Subject 1919 Maple Grove Road - Transportation Impact Assessment -

Addendum 1

Step 4 Submission (Analysis) - Circulation Comments & Response

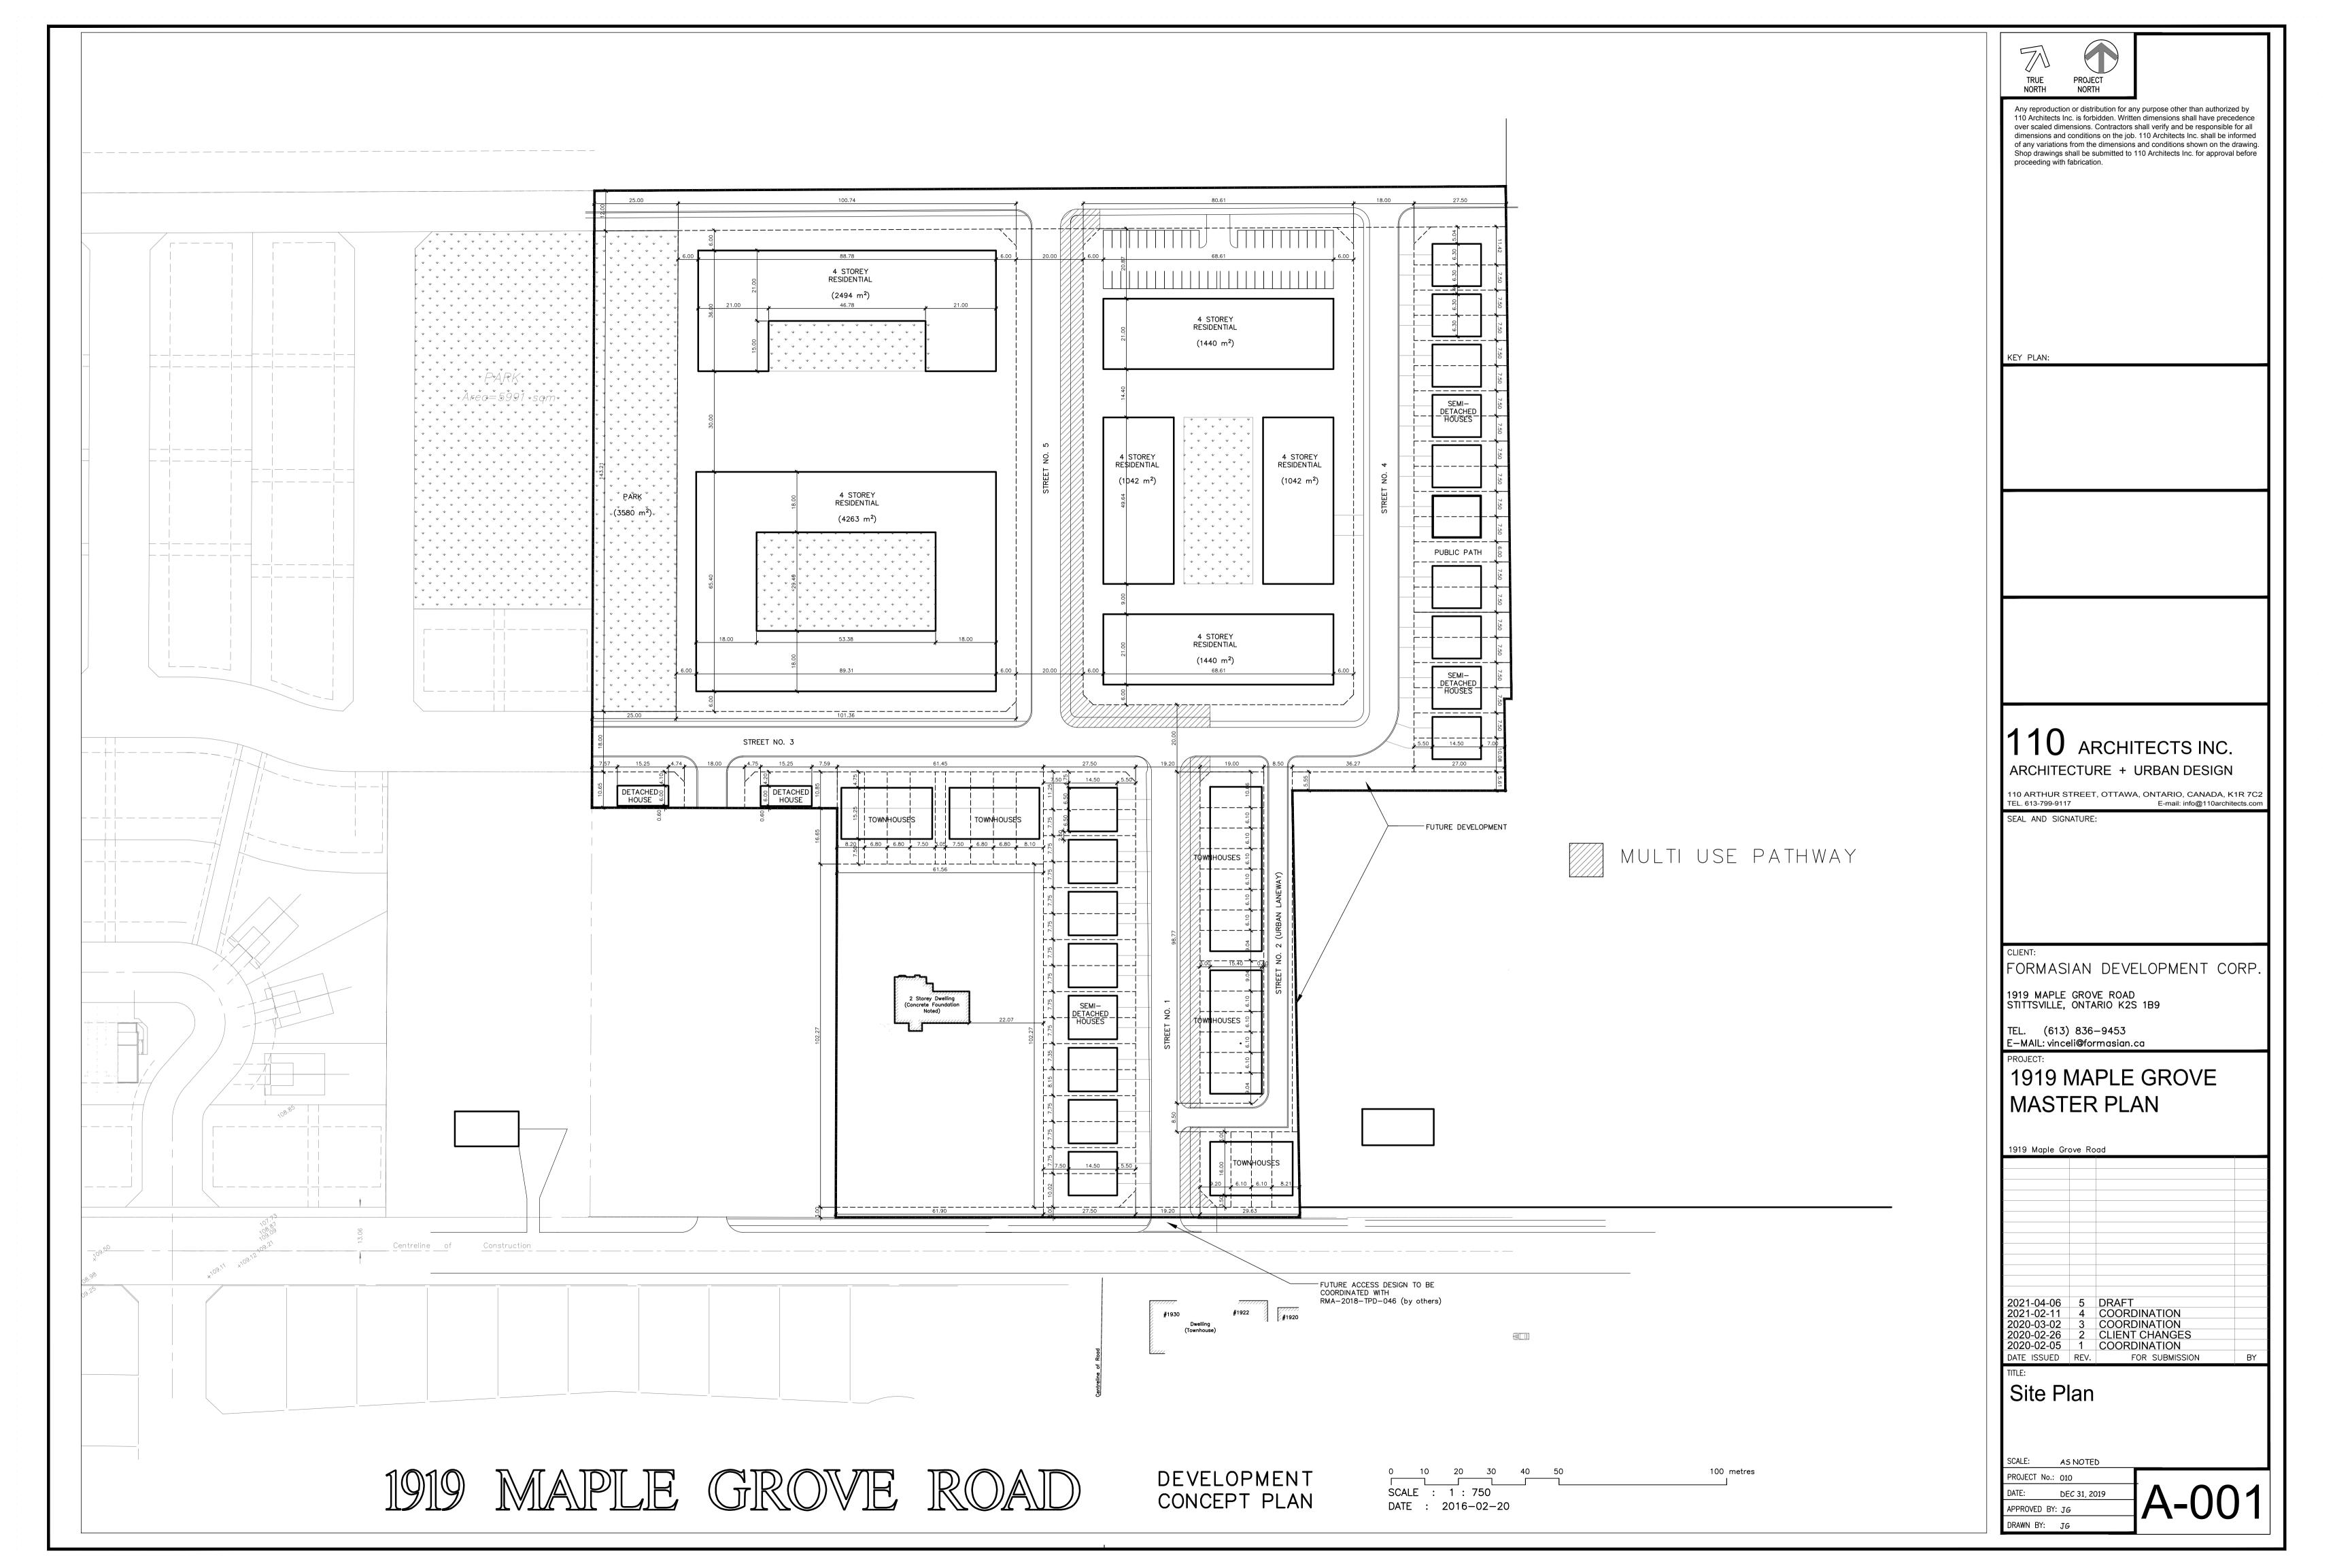
- 1. PM&S dwg: coordinate with 1981 Maple Grove for geometry of Street 4, regarding sidewalk locations.
 - > IBI Response: Noted. The potential sidewalk is now shown on the north side of Street 3 (formerly Street 4) in the conceptual traffic calming plan, and will be included on the PM&S drawing following Draft Plan approval.

- 2. PM&D: provide ultimate PM&S drawings in addition to the interim provided in the event Stittsville Main Street extension is constructed in time.
 - ➢ IBI Response: Acknowledged. 15m-radius temporary asphalt turning circles have been added to phasing plan as an interim measure until such time Stittsville Main Street is constructed. Geometric Road Design Drawings (GRDD) will be prepared following draft approval and will consider the ultimate configuration of the site, including traffic-calming measures targeting a 30km/h operating speed.

- 3. PM&S: Temporary cul-de-sac min radius is 15 metres. Design to conform to OPSD 500.020. Easement and agreement required if cul-de-sacs are on neighbour's property.

- 4. PM&S: indicate on the drawing at the access to MG that the design and PM&S to be constructed as per RMA form 1981 MG.
 - ➤ IBI Response: Acknowledged. A note has been added to the site plan, indicating "Future access design to be coordinated with RMA-2018-TPD-046 (by others)".

- 5. PM&S: PXO or a controlled crossing to be included on Street 4 at the intersections of Street 1 and Street 3. Curb ramp and TWSIs required on north side. One crossing per intersection. Crossing at Street 3 should be on side furthest away from corner.

- ➤ IBI Response: Temporary cul-de-sacs will be provided within the property limits. As these are temporary, they will be constructed without curbs per OPSD 500.010.

- Noted. A PXO will be added to the Pavement Marking, Signage and Roadway Geometry Drawings (now referred to by the City as GRDD plans) and will be submitted following Draft Plan approval.
